**PLANNED UNIT DEVELOPMENT
STAFF REPORT****Date: November 18, 2010****DEVELOPMENT NAME**

Group 1 Automotive, Inc.

LOCATION1005 and 1015 East I-65 Service Road South
(East side of East I-65 Service Road South, 690'± North of
International Drive).**CITY COUNCIL
DISTRICT**

CONTEMPLATED USEPlanned Unit Development Approval to allow shared
access and parking, between two building sites.**TIME SCHEDULE
FOR DEVELOPMENT**

SITE PLAN

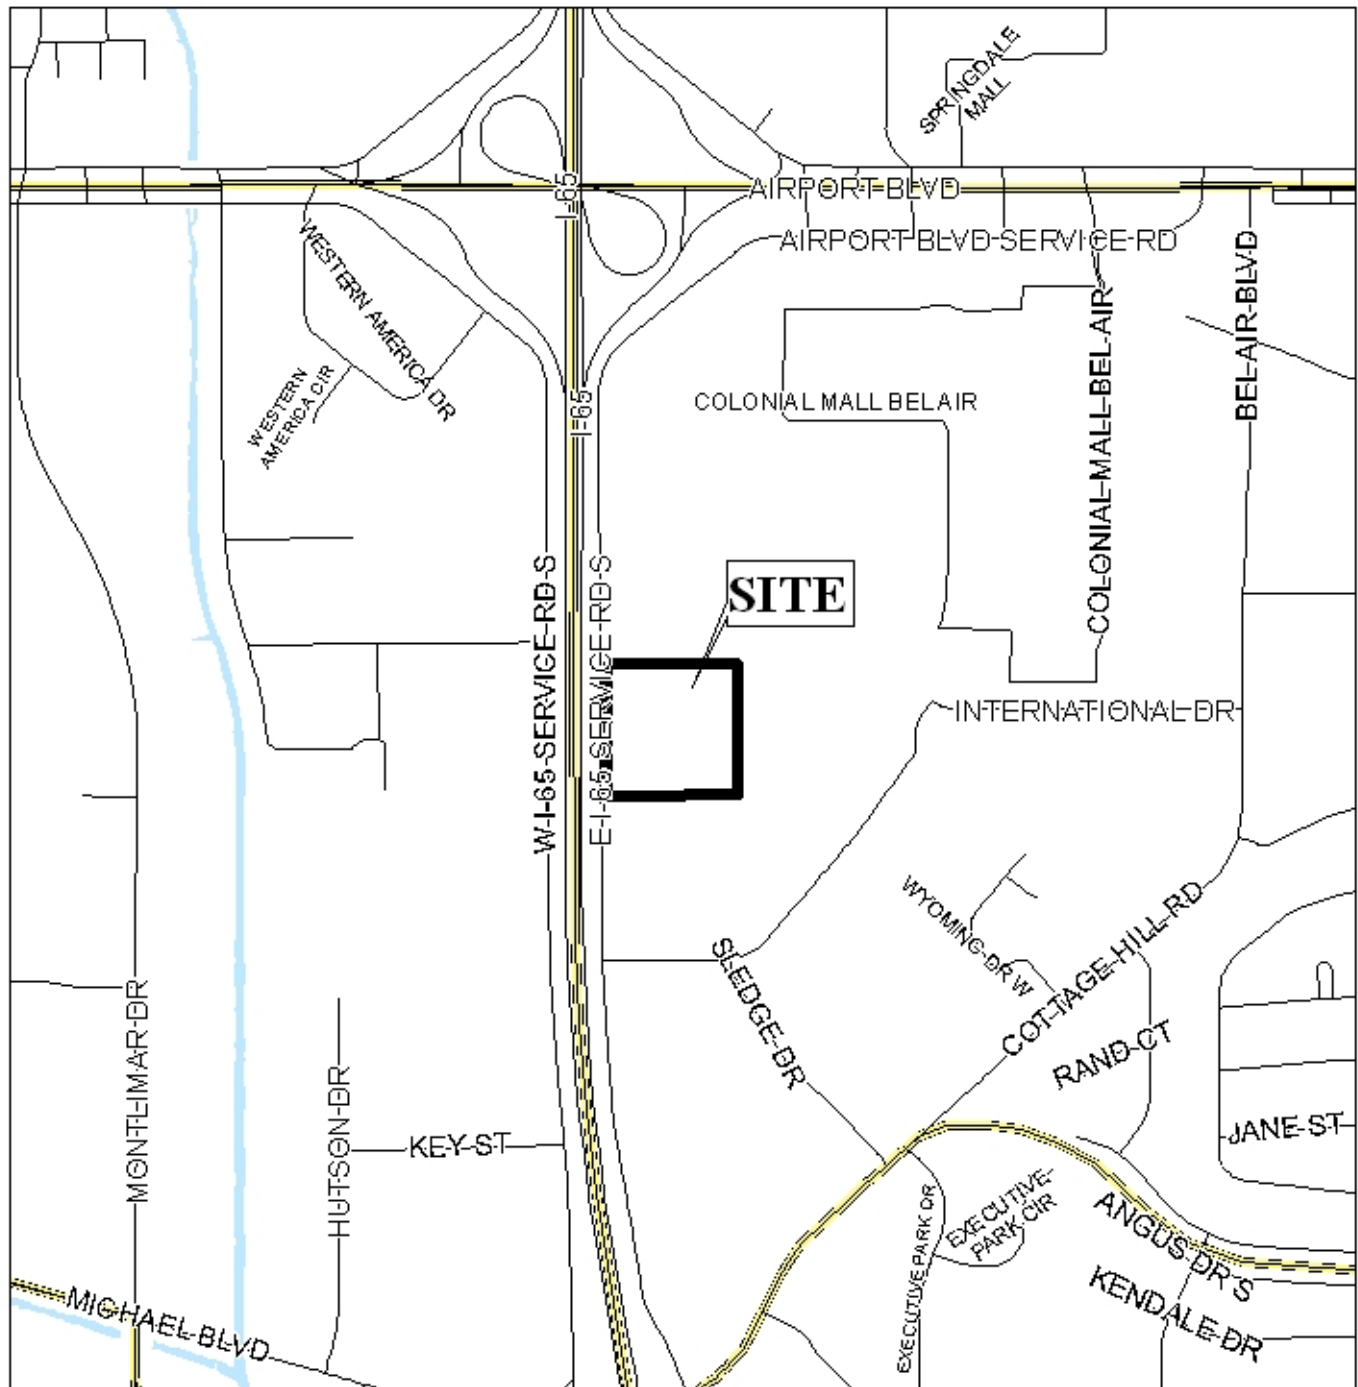
The auto inventory parking area will be accessed via a two-way entrance from the existing auto dealership to the South. The inventory parking area does not illustrate an access route to allow emergency vehicle circulation through the inventory area, as well as tractor-trailer delivery of vehicles. Trees and a detention area are also depicted on the PUD site plan.

Additionally, there seems to be a billboard land lease for a portion of the proposed inventory lot; therefore, delineation of the lease parcel from the actual parking area would also be required.

The proposed inventory lot is Lot 2, I-65 East Service Road Development, has a note limiting this lot to one curb cut to I-65 Service Road South. However, the proposed site plan does not illustrate a curb cut to this lot, since PUD approval is site plan specific, any changes to the approved PUD site plan must be approved by the Commission.

No dumpster is depicted on the PUD site plan; therefore, if a dumpster is proposed, it should be depicted on the site plan, or a statement should be provided indicating that no dumpster will be included as part of the development. Furthermore, the development of the inventory parking area must comply with all other codes and ordinances, including Section 64-6.A.3.c. of the Zoning Ordinance pertaining to the lighting requirements of parking lots.

Because the site will represent more than a 50% reduction or increase in building area, full compliance with the landscaping and tree planting requirements of the ordinance will be required of the automobile storage lot. As the existing car dealership site does not currently show adequate landscaping area, and because it appears that perhaps significant site design changes will be required to attain compliance, the applicant should be prepared to modify the site plan to illustrate tree plantings to comply with the frontage requirements of the Ordinance.

- 1) revision of the site plan to include a statement regarding the provision of a dumpster, or placement of a note on the site plan stating that dumpsters will not be provided as part of the development;

- 2) placement of a note on the PUD site plan stating that cross-access is limited to the illustrated access between Lot 2, I-65 East Service Road Development Subdivision and Lot 1, Interstate SE Subdivision, and that no vehicle inventory will be stored on adjacent lots until those lots are brought into compliance with the Zoning Ordinance;

- 3) submission of two (2) copies of the revised PUD site plan;
- 4) delineation of the billboard lease parcel from the actual inventory area;
- 5) full compliance with the Tree and Landscaping requirements of the Zoning Ordinance for the inventory site;

- 6) provision of frontage trees along I-65 Service Road on the existing car dealership lot;
- 7) compliance with Section 64-6.A.3.c. of the Zoning Ordinance pertaining to the lighting requirements of parking lots; and
